ARCHITECTURAL REVIEW BOARD MEETING

Thursday, September 24, 2026 at 6:30 PM

STAFF REPORT

Meeting Date:	September 24, 2026
Agenda Title:	COA 26-38 101 Main Street
Requested Action:	Construct Fence Along Rear Property Line
Department / Agency Lead:	Community Development
Staff Lead:	Whitney Burgess, Preservation Planner

Proposed Design

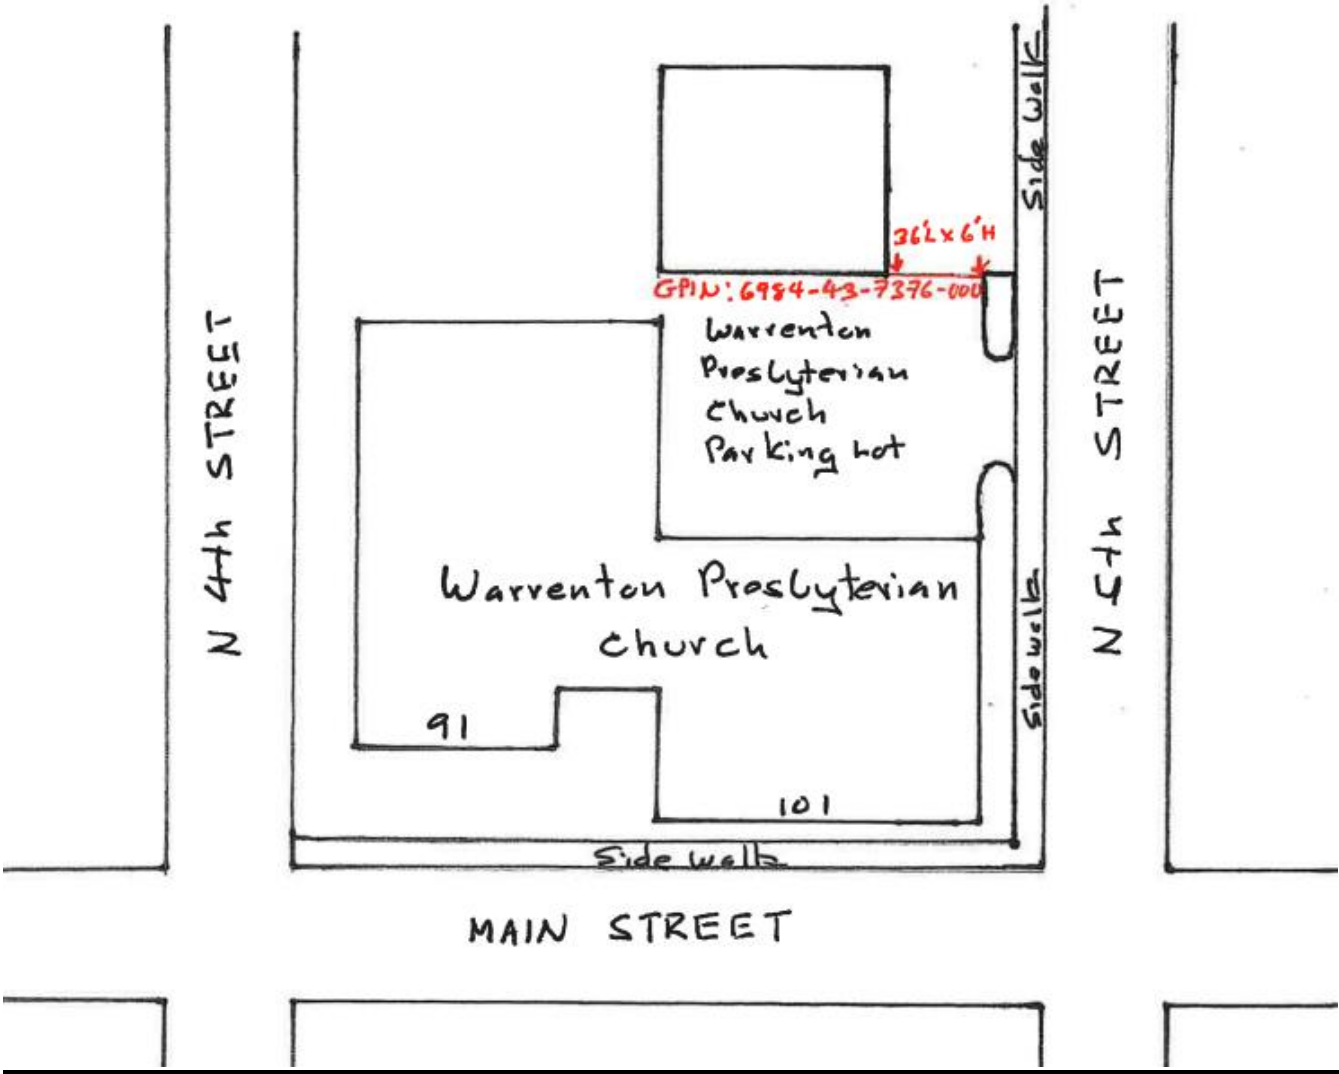
Historic District Guideline	Page No.	Analysis
2. SITE DESIGN		
B. Guidelines for Fences & Walls		
2. New fences should not exceed six feet in height, or the maximum allowed by the zoning district regulations	3.8

3. Design fencing and gates for visual interest in addition to function; choose appropriate materials such as stone, brick, cast stone, rusticated concrete block, cast cement, wood, iron, steel, or metal wire	3.8

4. For wooden stockade fences, avoid simplicity. Design with architectural details such as capped posts, pointed or shaped boards, varied board heights, or scalloped sections, for example. The rails should face the interior lot. Pressure treated lumber is acceptable but stained or painted is recommended.	3.8	
Best Practices		
For fences and walls between properties, permission and approval of the adjoining owner should accompany the Architectural Review Board application for review consideration	3.8

Staff recommends approval of Certificate of Appropriateness 26-38 for the request to construct a wooden privacy fence along the rear property line at 101 Main Street, as described and depicted in the application and plans, provided the following conditions are met:

- 1) All necessary permits are acquired; and
- 2) The fence should be stained or painted; and
- 3) Fence height cannot exceed 6 ft tall, per Zoning Ordinance 2-19.1

Proposed Designs (Facade)

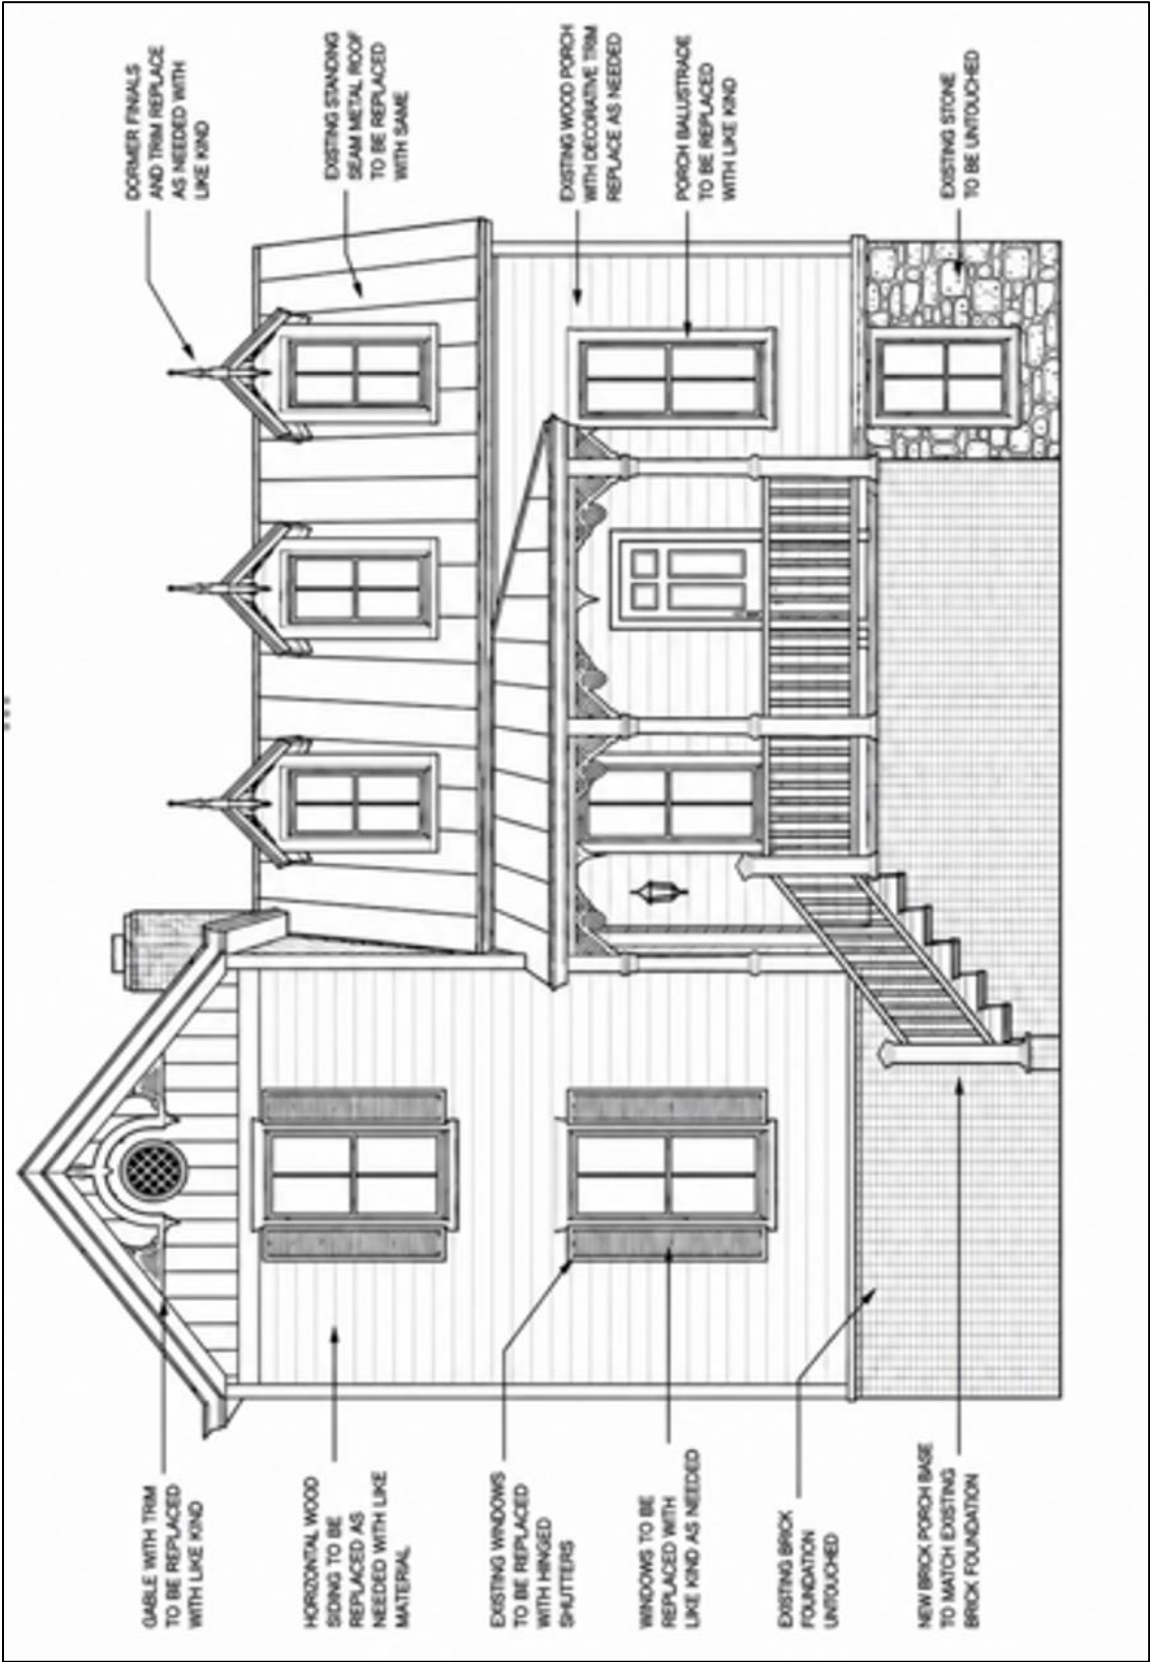
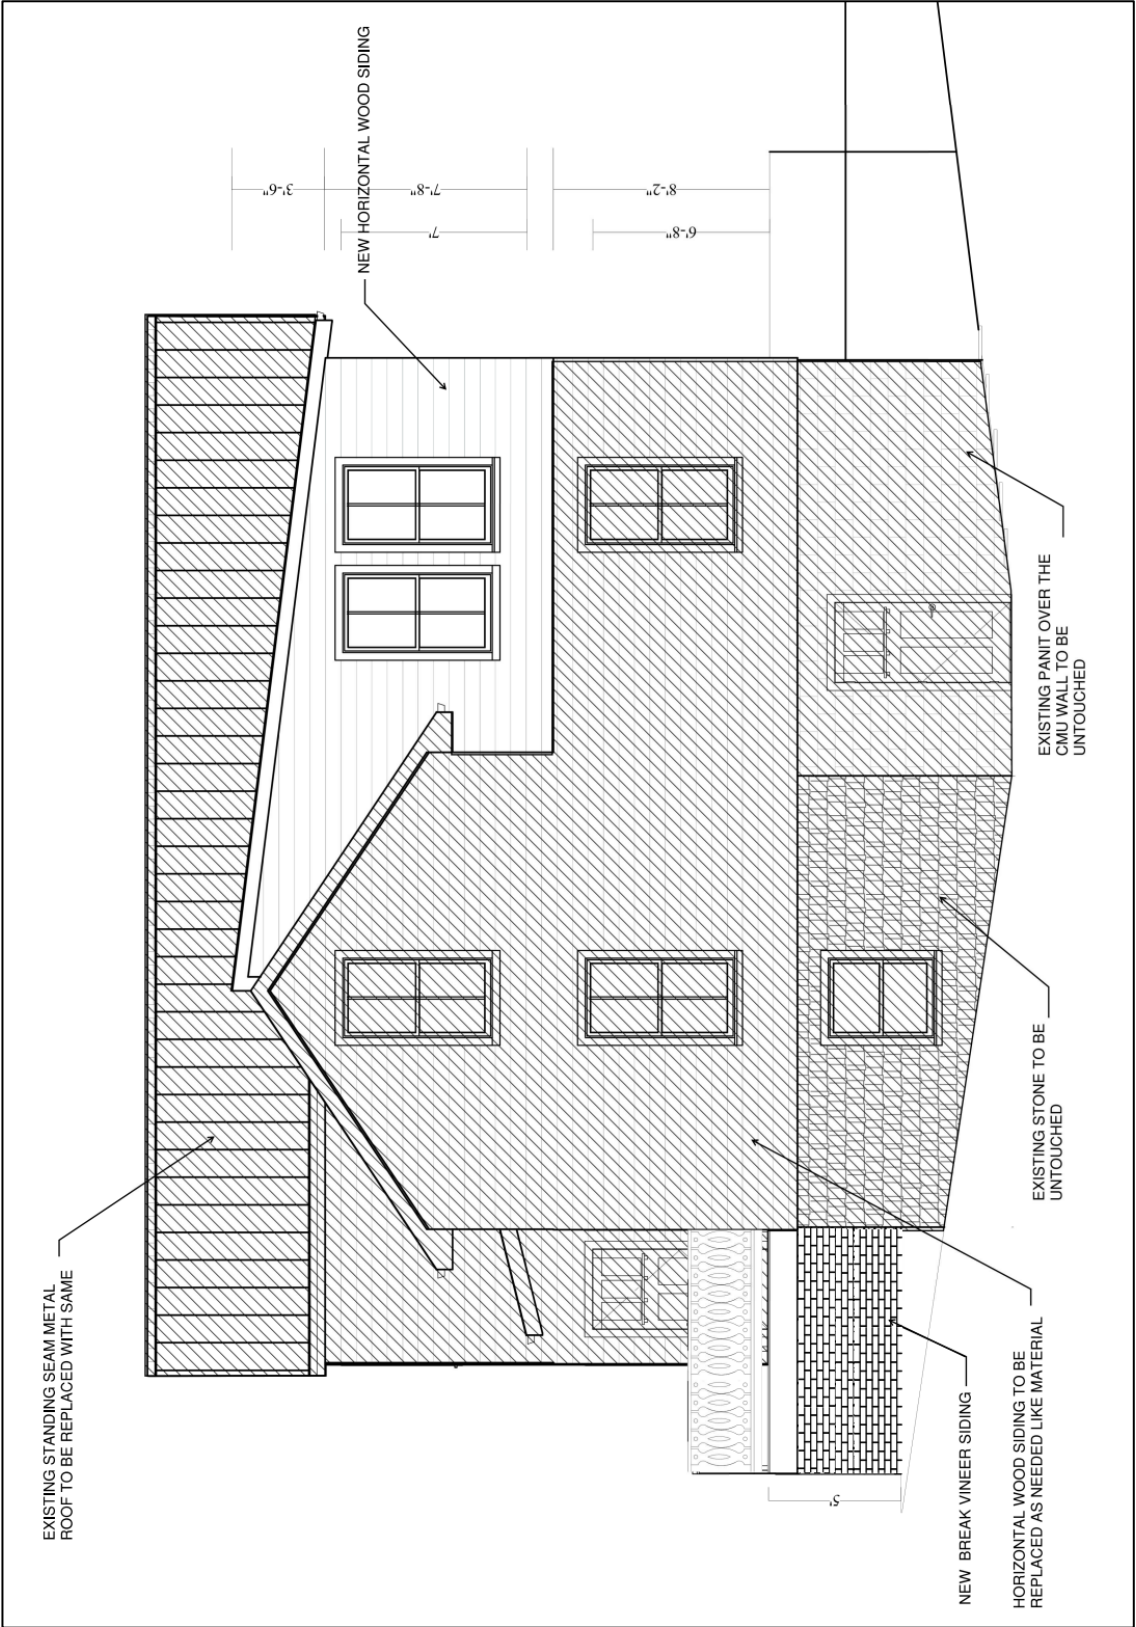
The plan set has some errors and typos and design components that could use clarifications. The only matter to waffle over is the addition of the third dormer and the door/window across the original portion of the façade (1.5 story). It would not be an adverse effect and would complement the existing symmetry, but it will alter the fenestration pattern. If those items are not deal breakers for any ARB members, I recommend conditional approval with the following stipulations:

1. All required permits must be acquired; and
2. An updated plan sheet showing accurate depiction of existing architectural details and proposed details across the façade is submitted for final review; and

3. The new second-floor addition must extend southeast from the rear of the existing one-and-a-half story roofline as not to add vertical height to the façade or expand the building footprint; and
